Project Name:	Coldharbour Farm Road, Emsworth
Document Reference:	187.0018/TN/2
Document Name:	Transport Note
Prepared By:	Mark Smith (May 2026)
Checked By:	Mark Smith (May 2026)
Approved By:	Mark Smith (May 2026)

Designers Response Road Safety Audit
Coldharbour Farm

Road Safety Audit Report

Proposed Continuation of Coldharbour Farm Road Emsworth

DRAWING No: JUBB_XX_XX_DR_C_100

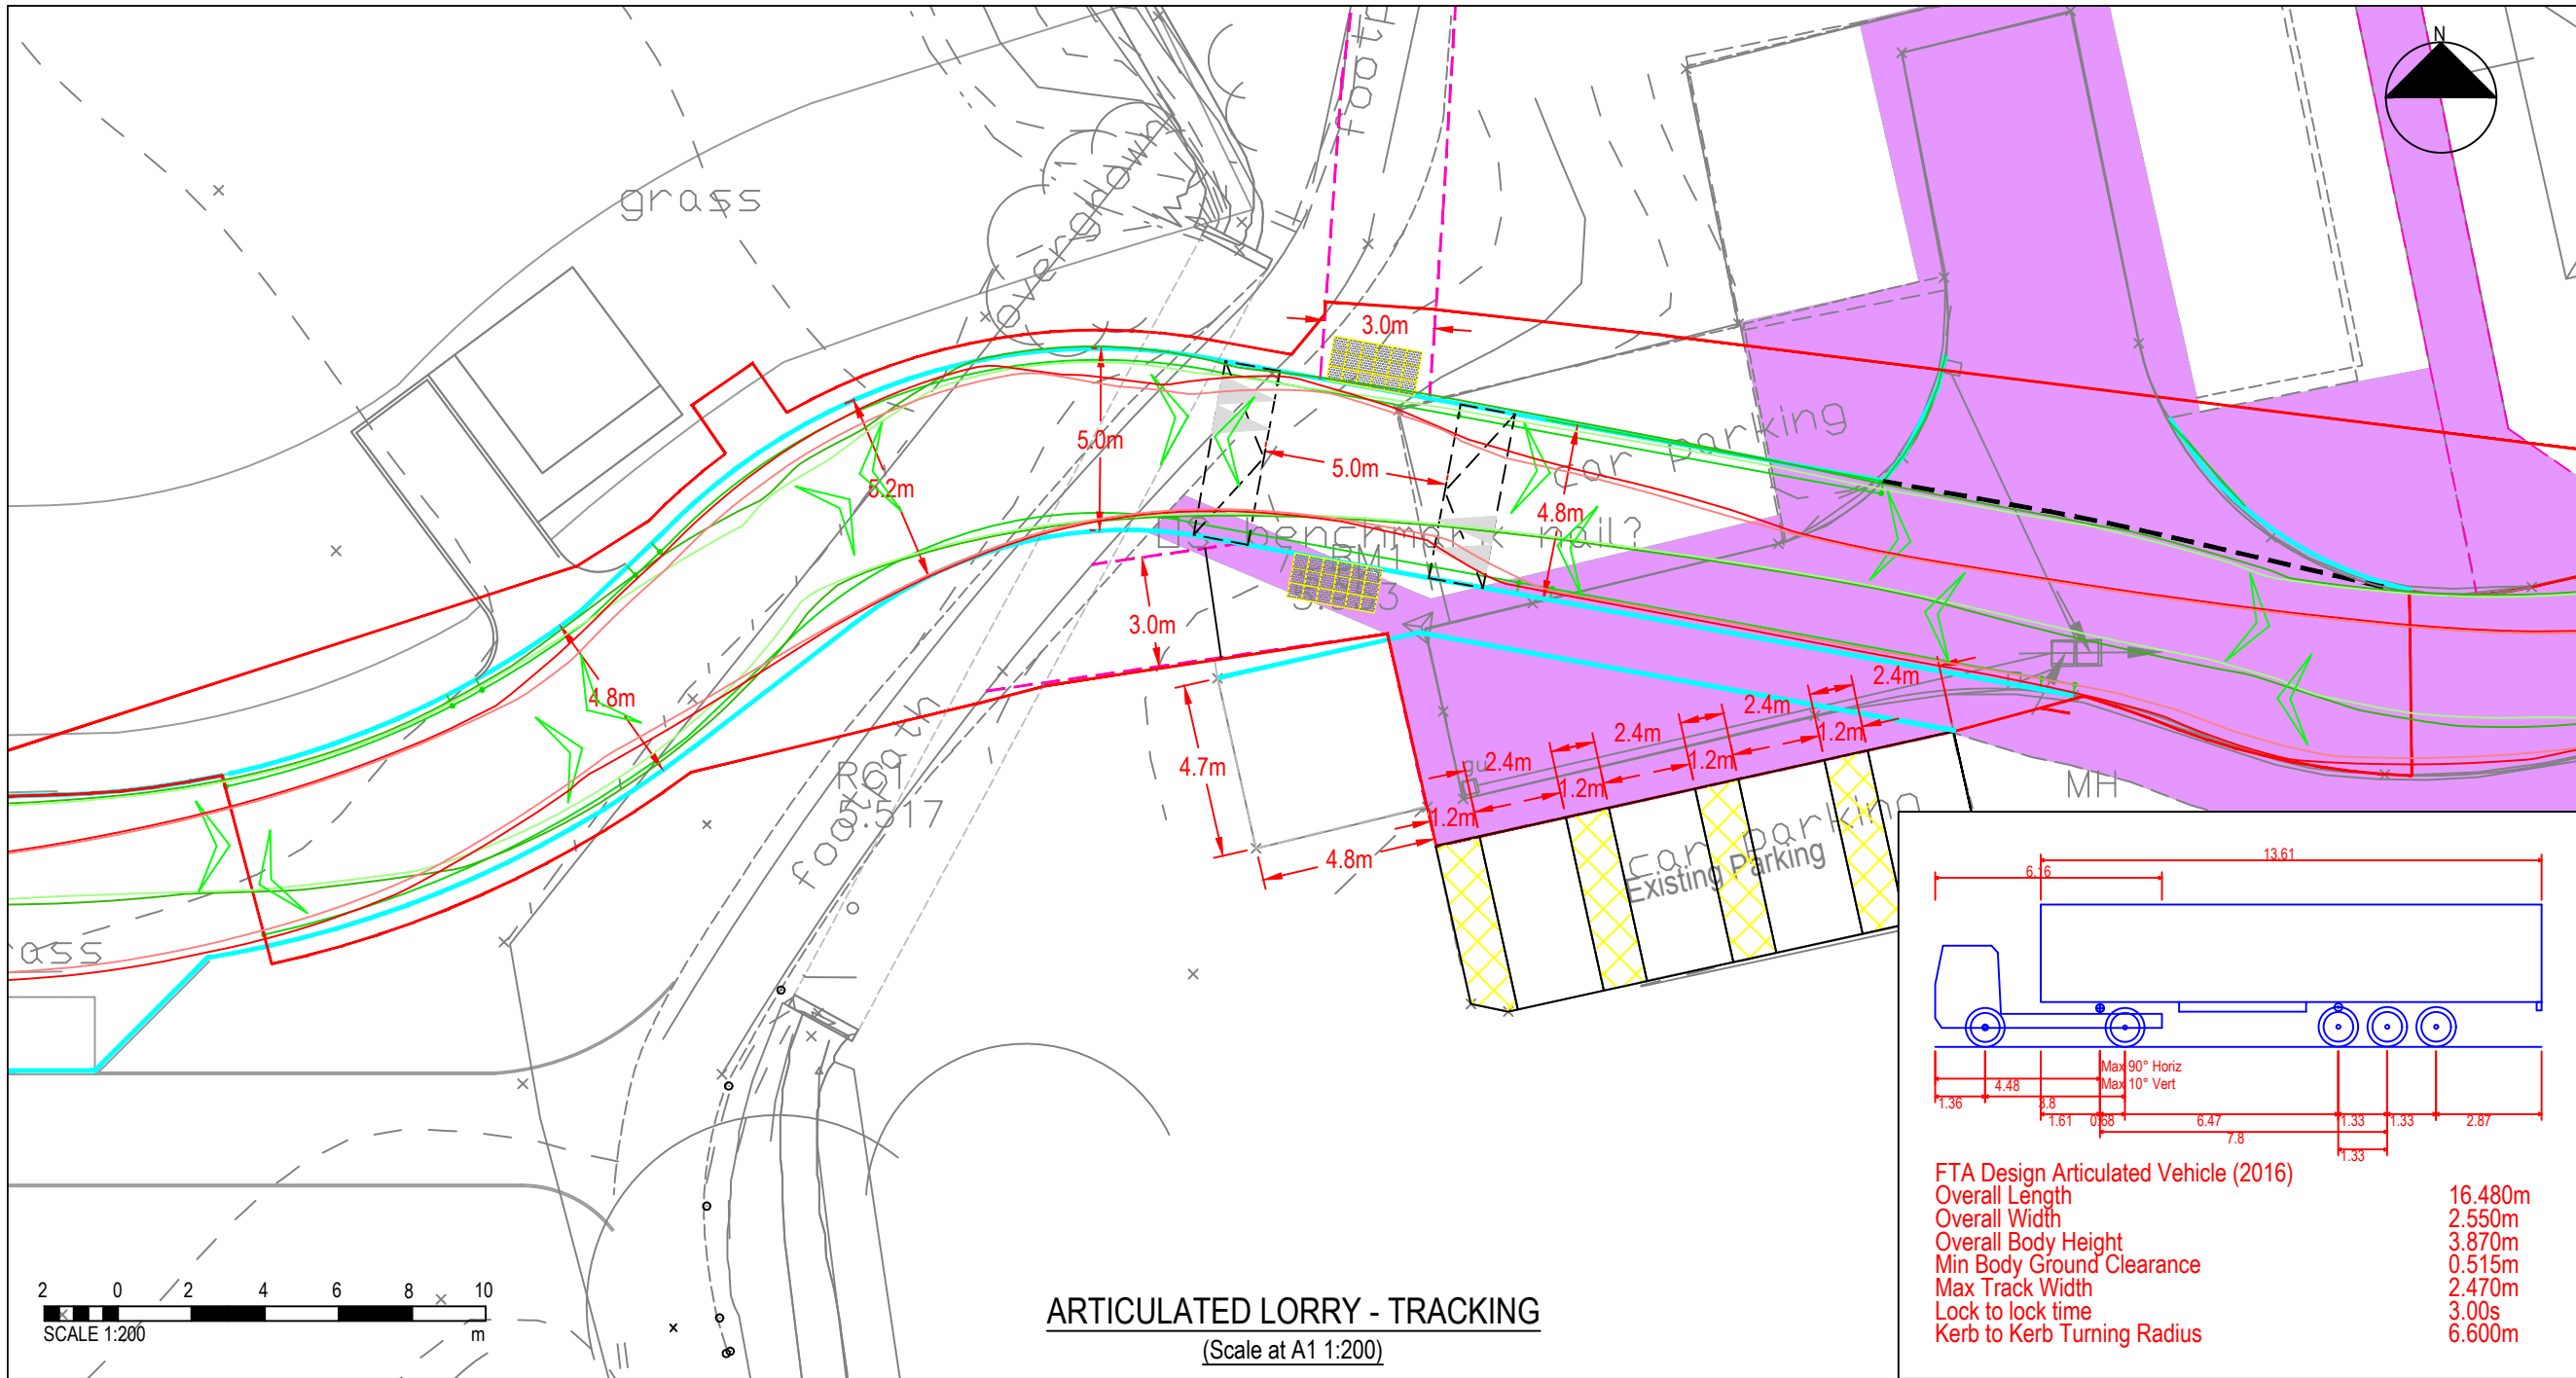
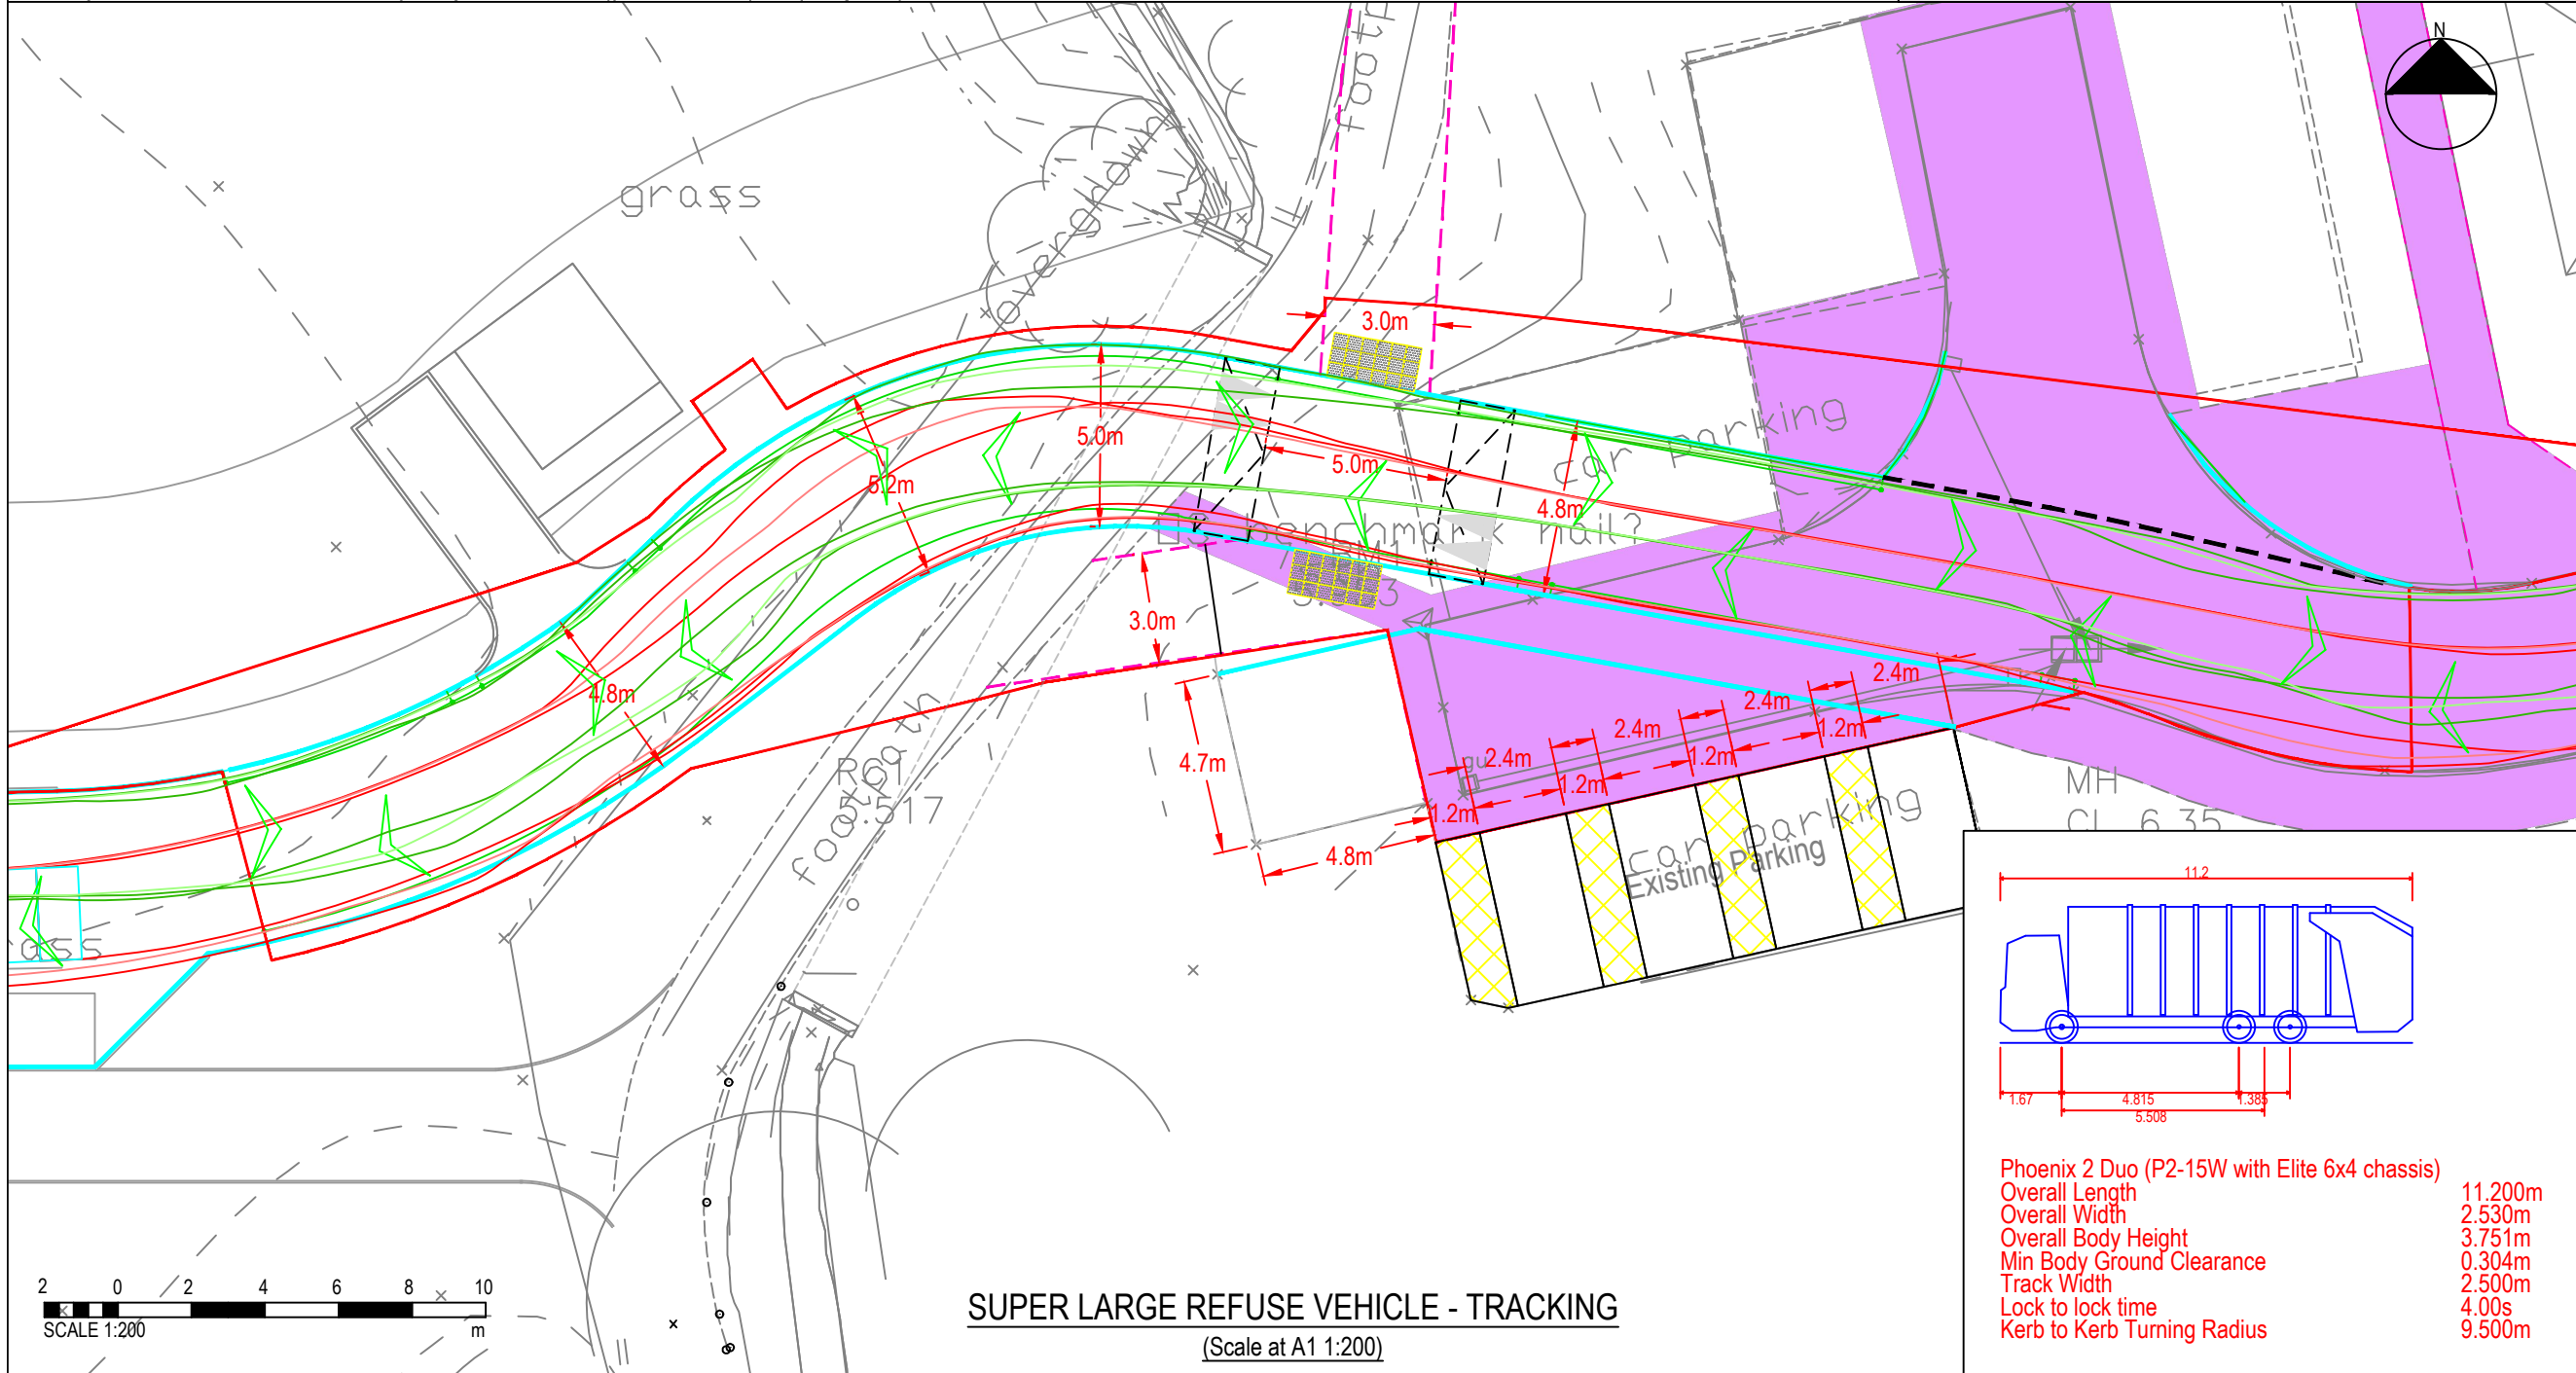
B.4.1 - Cyclists are likely to continue without giving way to traffic. It is recommended that an appropriate level of visibility is achievable.

B.4.2 - Non-motorised users at and on approach to the uncontrolled crossing may not be clearly visible during the hours of darkness. It is recommended that visibility is achievable to the tangent and that the proposed crossing point is illuminated adequately with a column provided immediately to the west of the crossing point as previously proposed.

Suitable visibility splays for cyclists are as shown on Drawing 23339-JUBB-XX-XX-DR-X-000100 REV C13. In dashed orange. With regards to lighting, this has been confirmed as suitable by the lighting designer.

Suitable visibility splays for pedestrians are as shown on Drawing 23339-JUBB-XX-XX-DR-X-000100 REV C13. In dashed yellow. With regards to lighting, this has been confirmed as suitable by the lighting designer.
